JORDAN VALLEY WATER TREATMENT PLANT
FILTER AND CHEMICAL FEED UPGRADES

JVWCD PROJECT #4289

ADDENDUM NO. 1
TO THE
CONTRACT DOCUMENTS

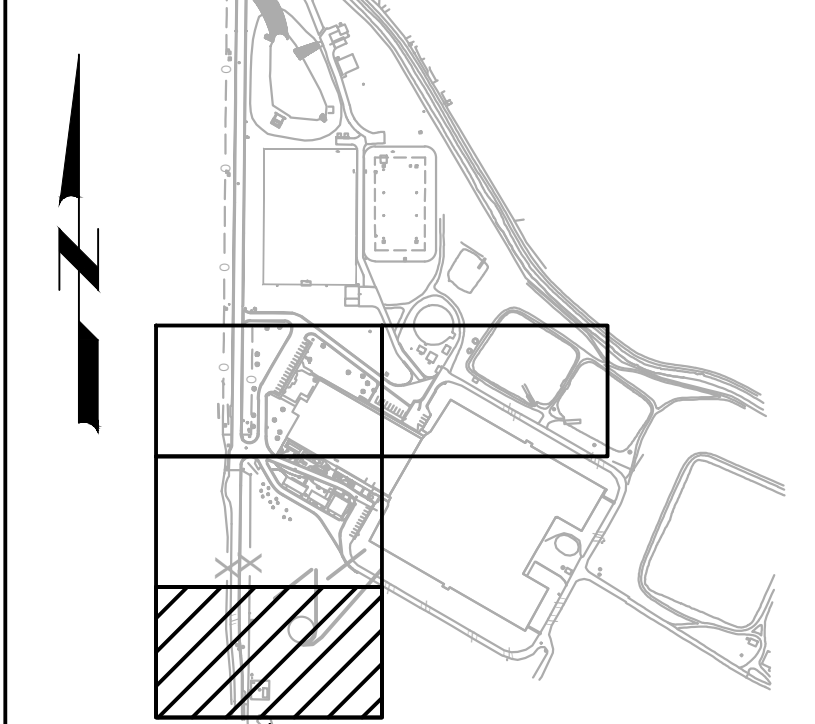
5. DEMOLISH CONDUITS AND WIRE BETWEEN BACKWASH TANK AND FLUORIDE BUILDING.
6. INTERCEPT TWO EXISTING CONDUITS CONTAINING 480V POWER AND FIBER OPTIC FOR THE CULINARY RESERVOIR. REFER TO DRAWING 01E02 FOR NEW PULLBOX AT THIS INTERCEPTION POINT AND NEW TERMINATIONS FOR 480V POWER WIRING AND FIBER OPTIC TO CULINARY RESERVOIR.

7. FUSED DISCONNECT.
8. SALVAGE POWER PULLBOX AND RELOCATE AS SHOWN ON DRAWING 01E02.
9. DEMOLISH CONDUITS AND WIRE FROM POINT OF INTERCEPTION TO THE FLUORIDE BUILDING.

JOB NO.
202001.10
DRAWING NO.
01E02
SHEET NO.
OF

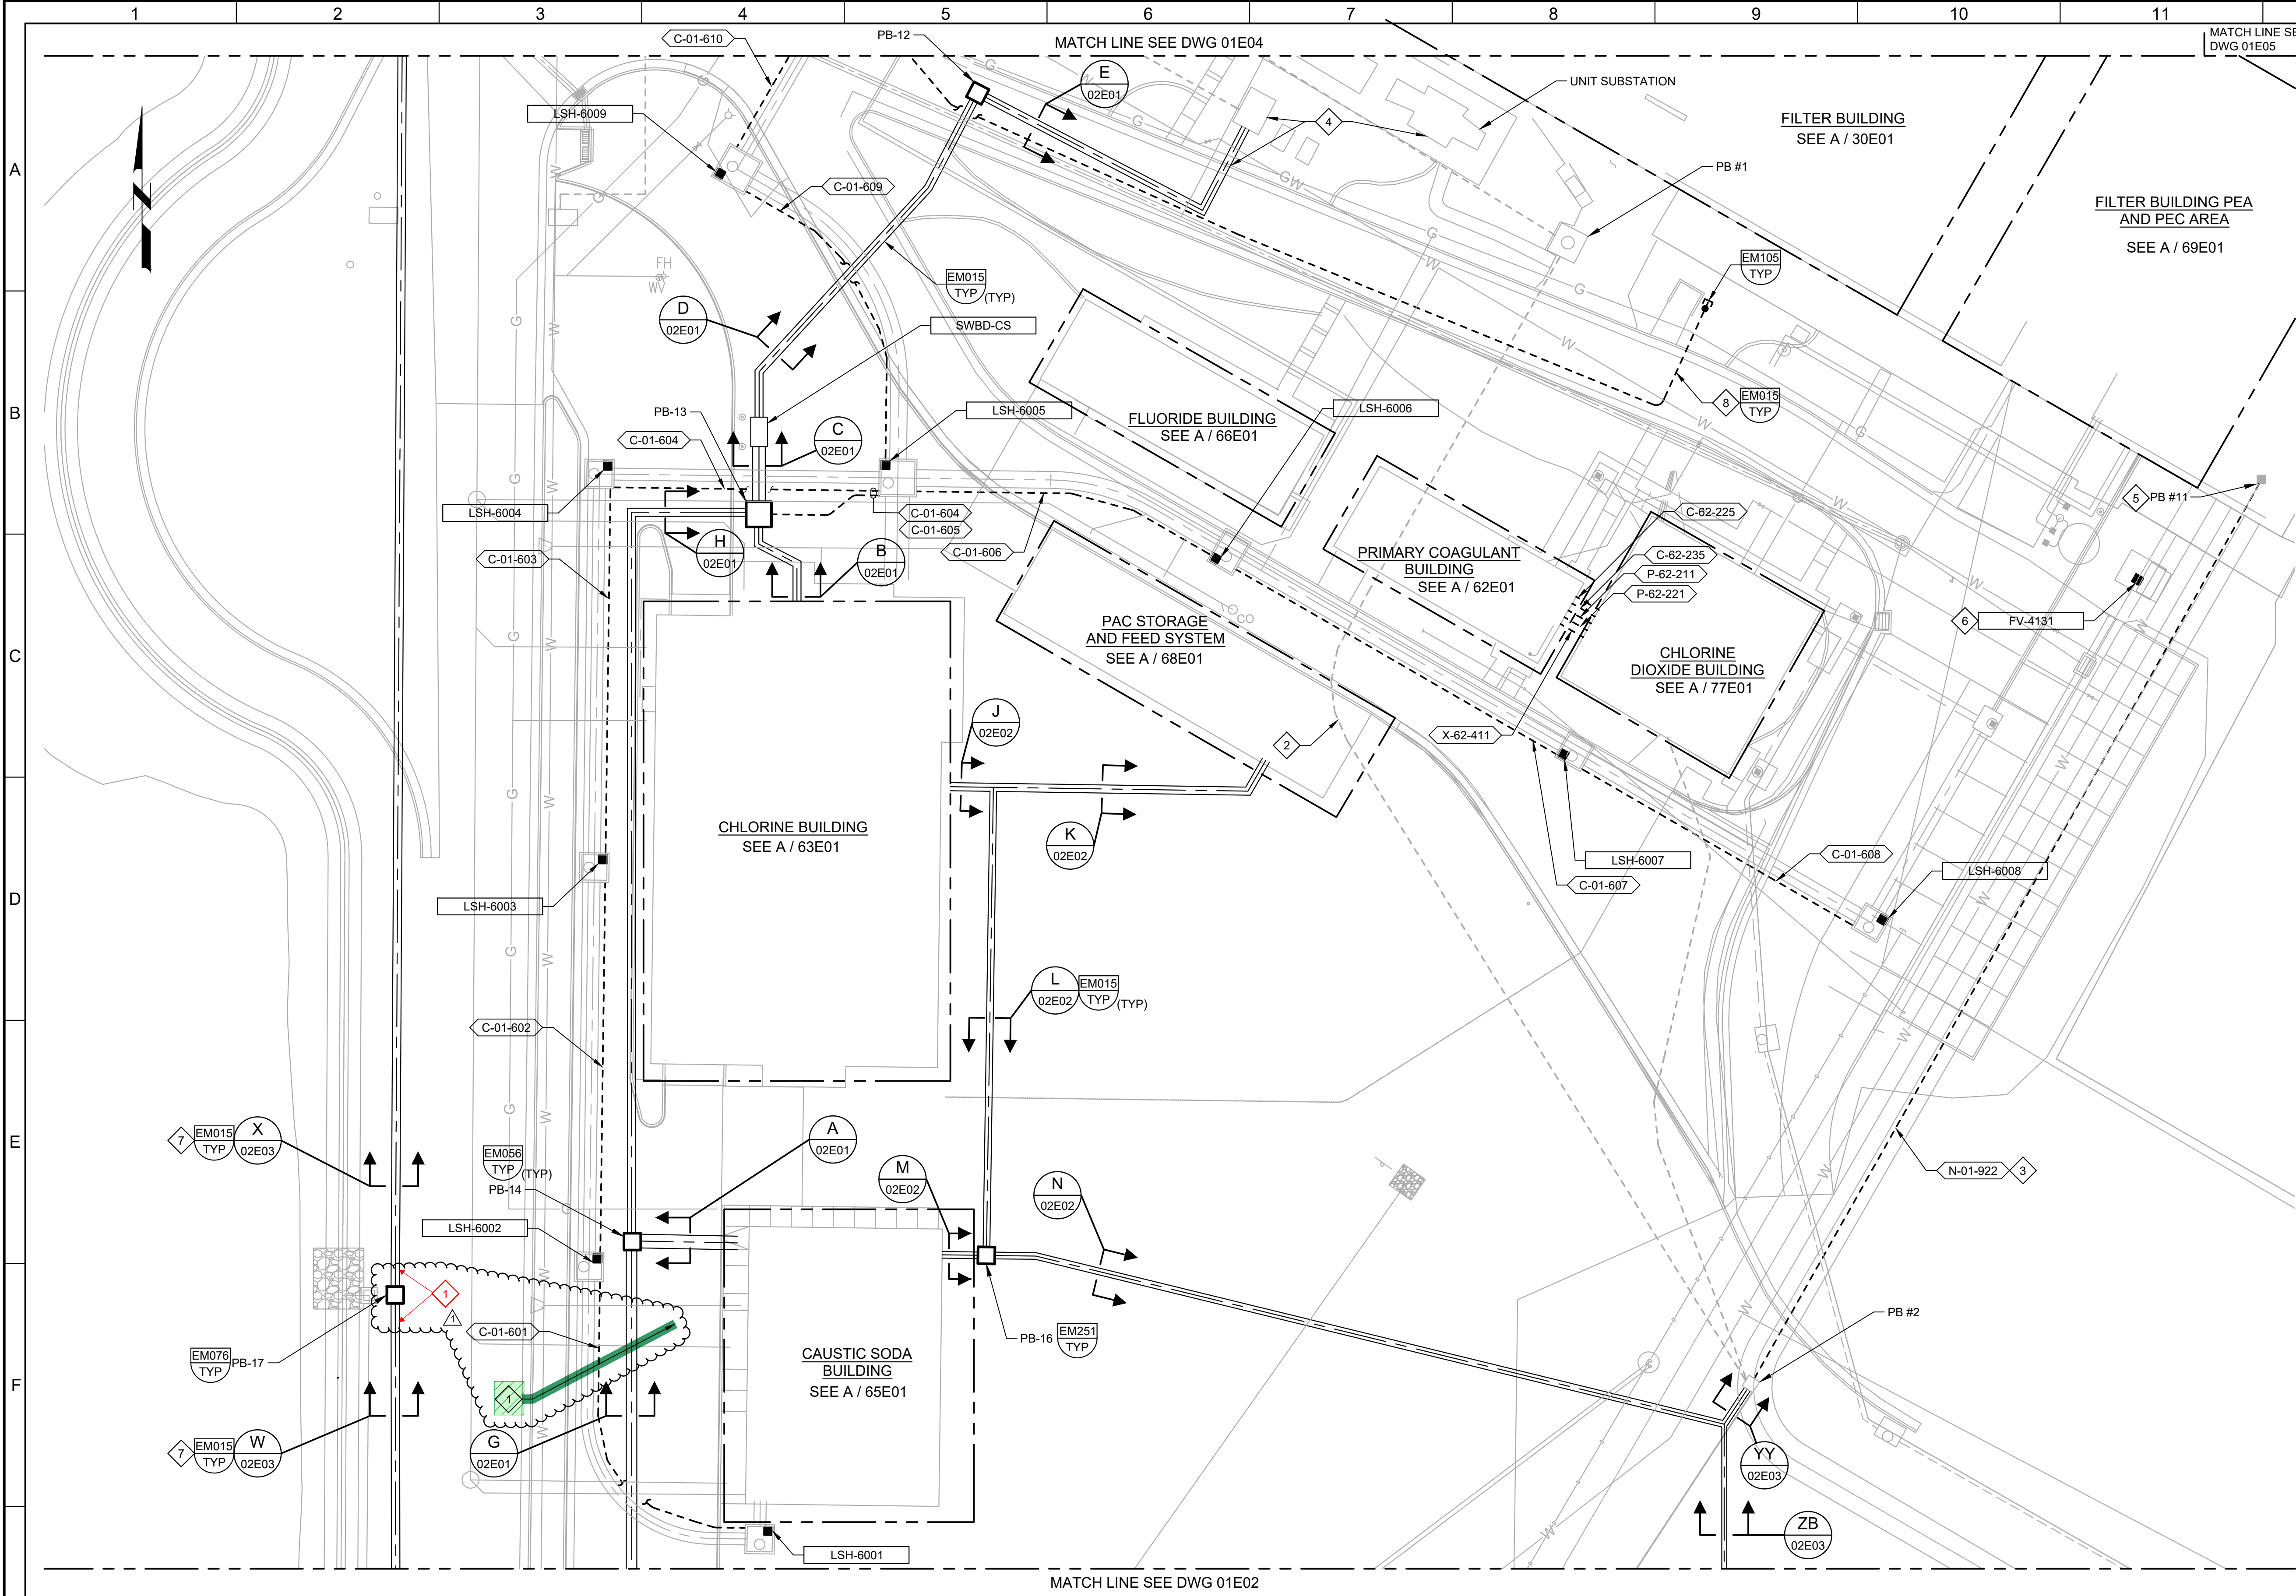
3. SOUTH SECURITY GATE, RELOCATED FROM EXISTING LOCATION. MODEL VPL-24, AG# AG8617, SERIAL NO. G-JA15-C03975. PROVIDE ALL NECESSARY CONDUIT AND WIRING TO MATCH EXISTING LOCATION.

4. STUB UP FOR SECURITY CAMERA, TO BE RELOCATED FROM EXISTING LOCATION.
5. PROVIDE CONCRETE CAP OVER DUCT BANK AS SHOWN IN THE TYPICAL DETAIL.
6. RELOCATE EXISTING PULL BOX FROM DRAWING 01DE01.
